Re: Interpretation for RZ 1999-HM-011 and FDPA 1999-HM-011, Woodland Park,
Tax Map 16-3 ((1)) 25-D2 (Formerly Tax Map 61-3 ((1)) Pt. 25D and 16-4 ((1)) 32B):
Layout Modification for Land Bay C-2, Buildings, Parking and Landscaping (Revised)

**INTERPRETATION EXHIBIT
VAN METRE @ WOODLAND PARK
LAND BAY C-2**

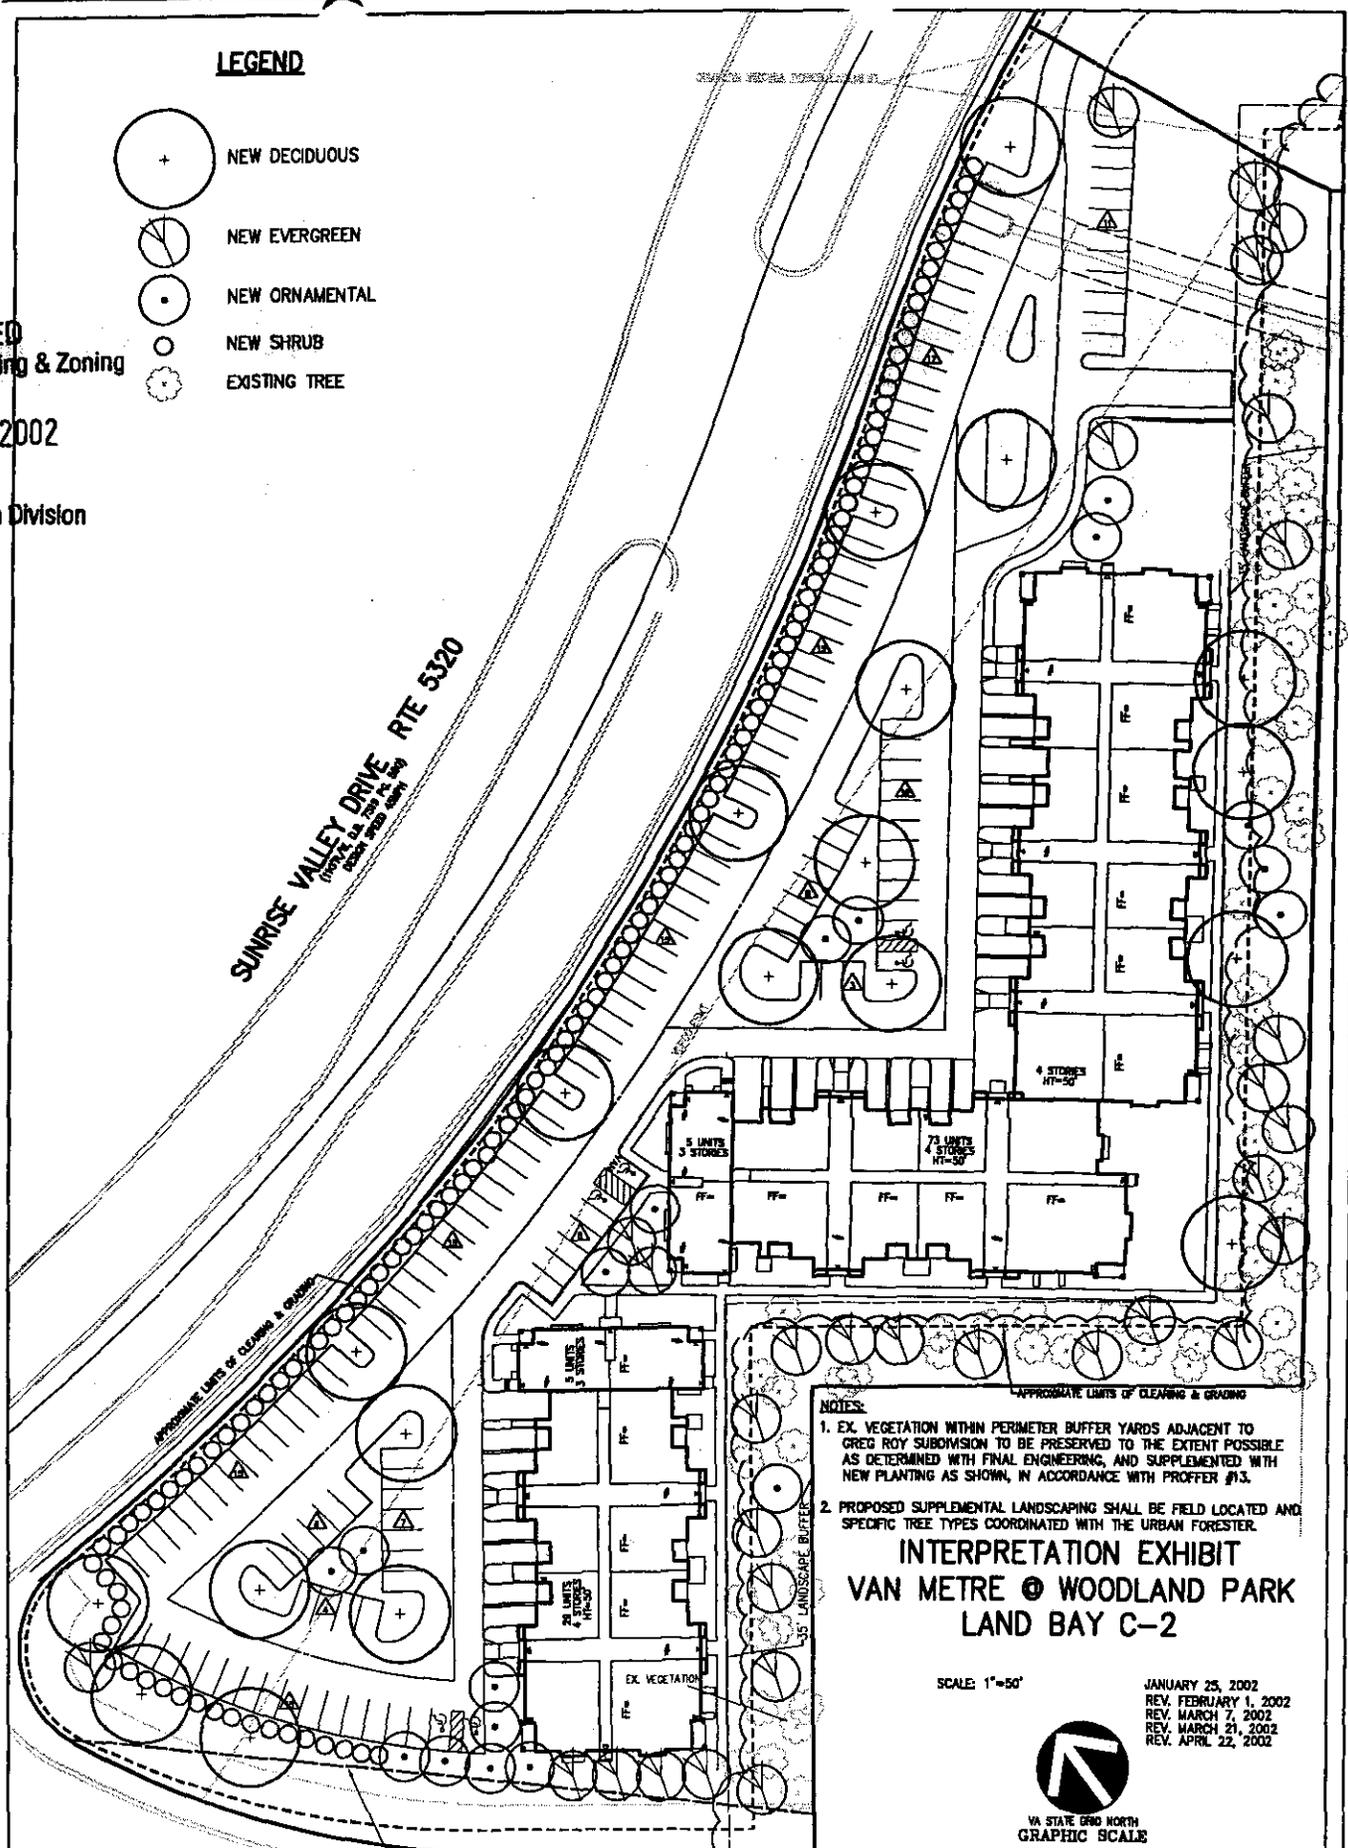
Landscaping: You noted that additional landscaped islands should be provided along Sunrise Valley Drive to break up the number of parking spaces in a row. Additionally, you requested further landscaping in the open space areas on the plan.

Urban Forestry Comments: After talking with Hugh Whitehead of Urban Forestry, you noted that the trees placed directly in the Dominion Virginia Power easement running through the property may need to be moved so as not to infringe on the easement.

Urban Forestry also noted that the existing and proposed trees shown were not necessarily indicative of what existed or could be planted in the 35' buffer next to the Greg Roy subdivision.

The revised exhibit shows additional landscaped islands along the parking on Sunrise Valley Drive as well as vegetation in the open space areas. These changes should still comply with the approved FDPA.

The Dominion Virginia Power easement through the property does not permit buildings to be constructed within the easement but does allow certain deciduous trees. VIKA will address this issue in detail during the review of the site plan to ensure that the setback from the easement is maintained as required. This issue will be resolved through coordination with Dominion Virginia Power during the site planning process.

As we discussed, the exhibit reflects the appearance of the buffer as shown on the FDPA. VIKA will work to address this issue during review of the site plan. A note has been added to the exhibit stating, "Proposed landscaping shall be field located and specific tree types coordinated with the Urban Forester."
